DEVIATION REQUEST AND DECISION FORM

Project Name : Eagle Rising PCD File No. SP205 & SF2225
Schedule No.(s) : 52290-00-034 & 52290-00-035
Legal Description : See Attached

A deviation from the standards of or in Section(s) **ECM 3.3.3 B and C** of the Engineering Criteria Manual (ECM) is requested.

HEC-RAS Cross Section Location and Photo Key Map

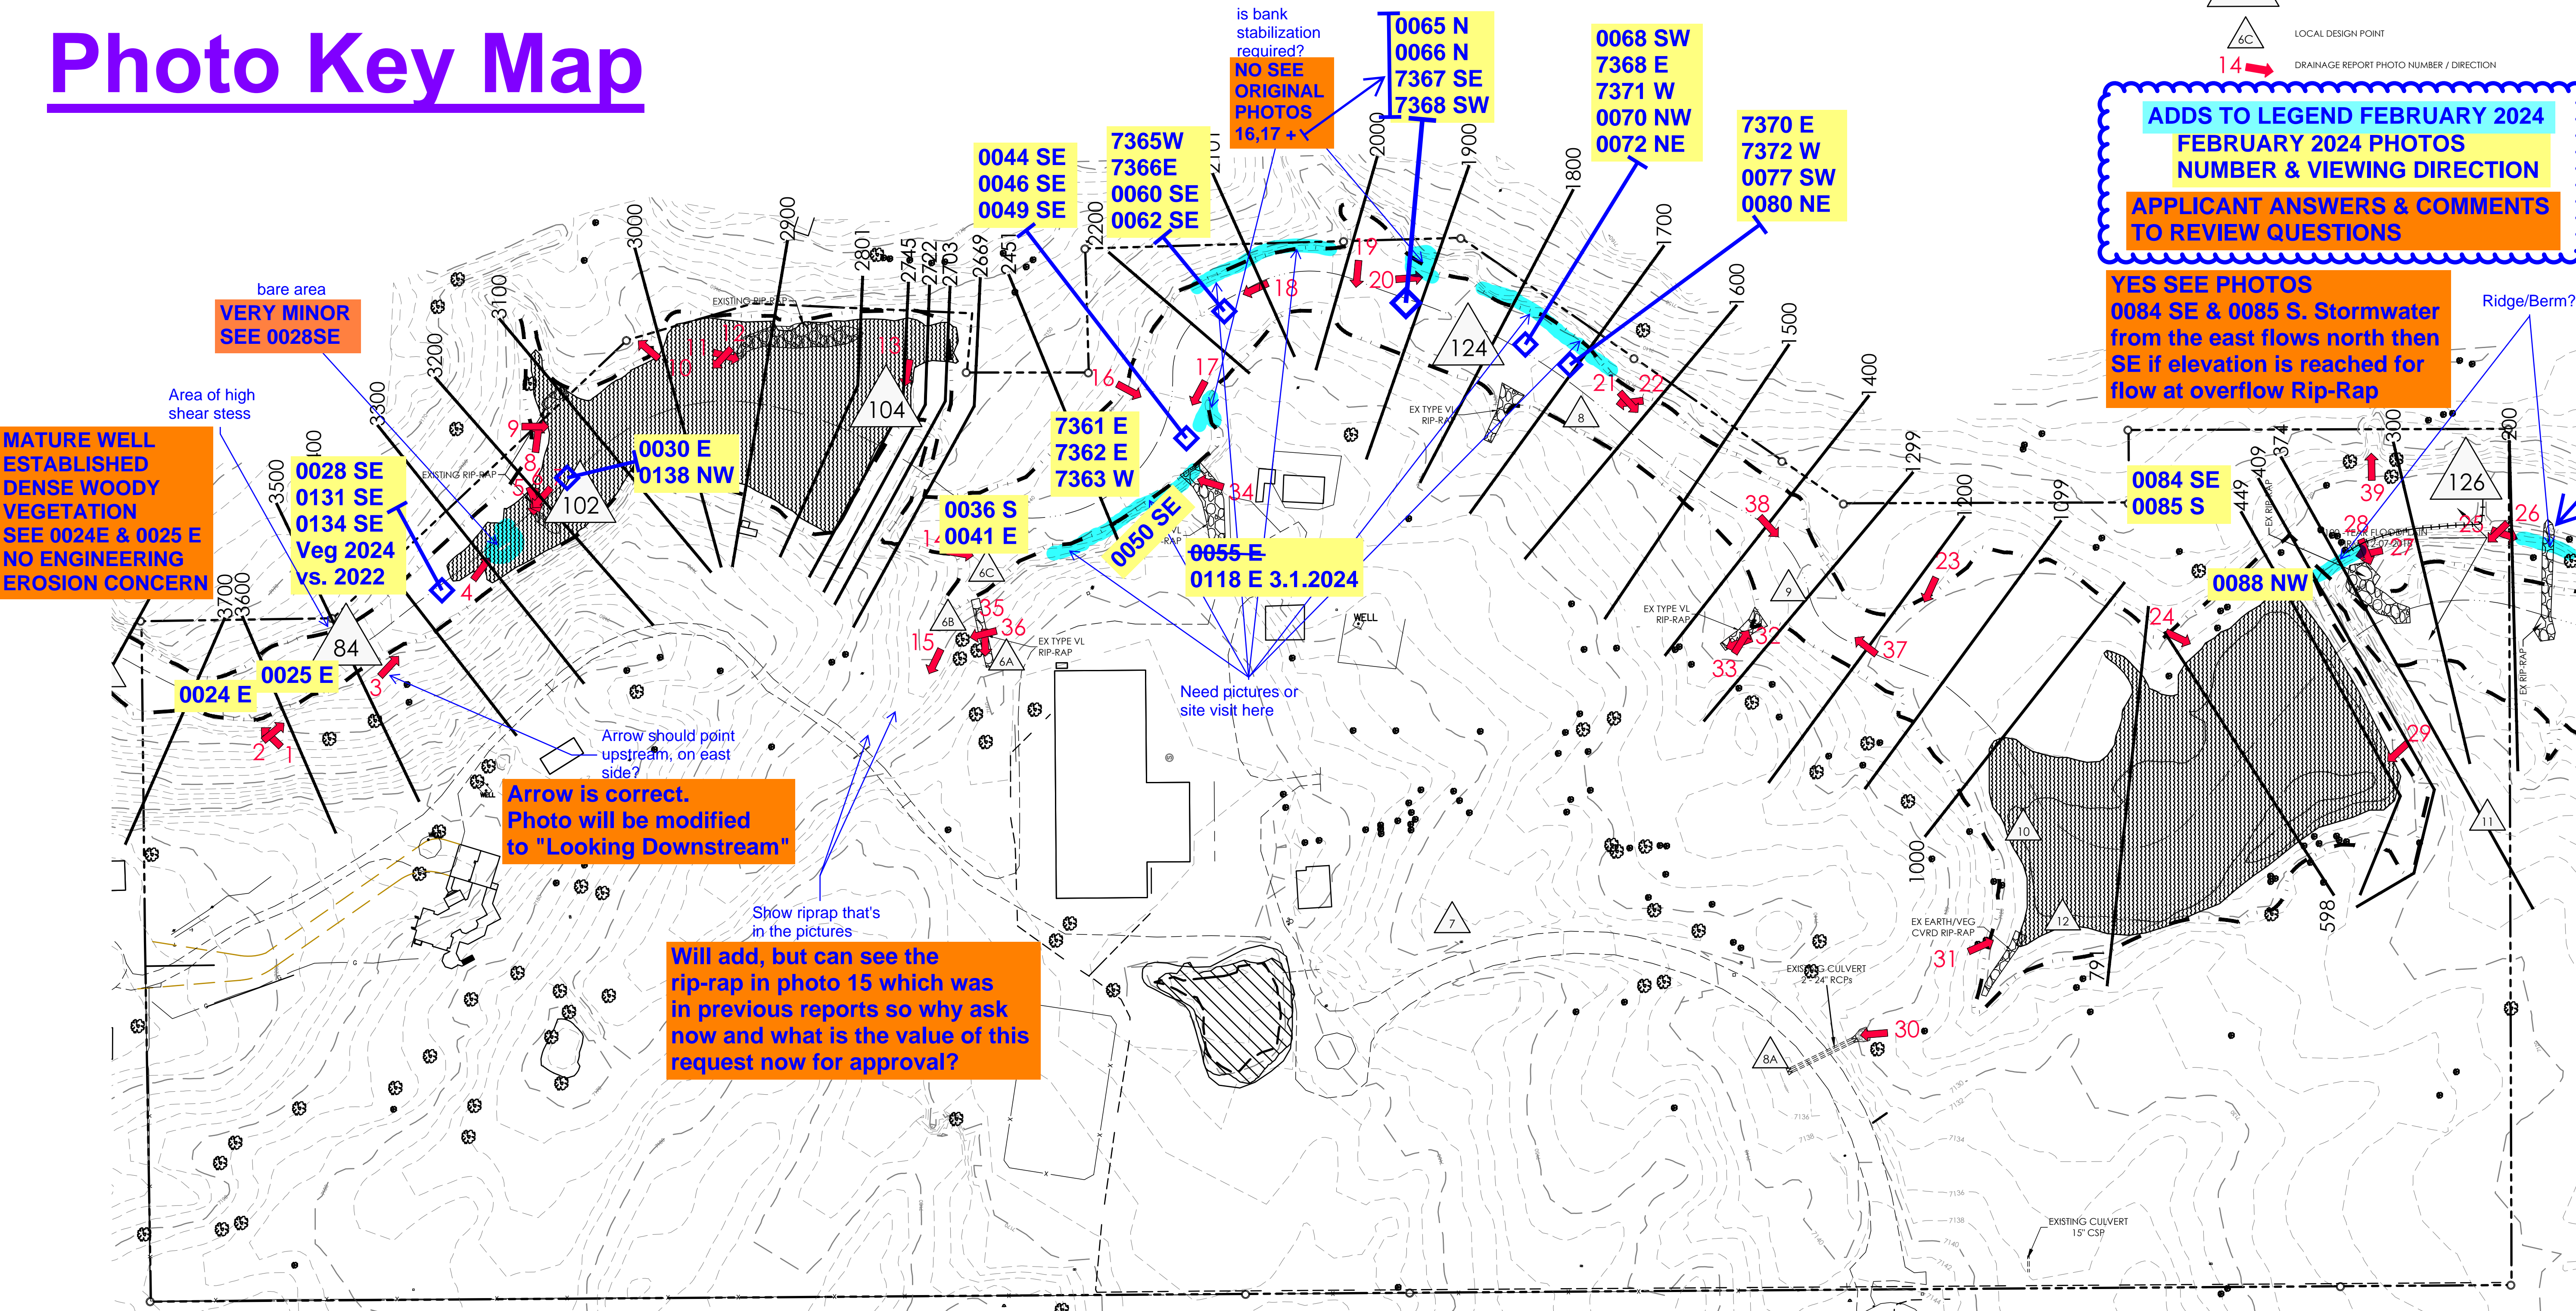
SP205 + SF2225: DRAWING EXTRACTED FROM THE DEVIATION REQUEST SUBMITTED FOR EMC 3.3.3 B & C TO SHOW LOCATIONS OF THE ATTACHED ADDED PHOTOS JEFF RICE REQUESTED JANUARY 29, 2024

Added photos requested by Jeff Rice in the EDARP 1.29.2024 Review Comments
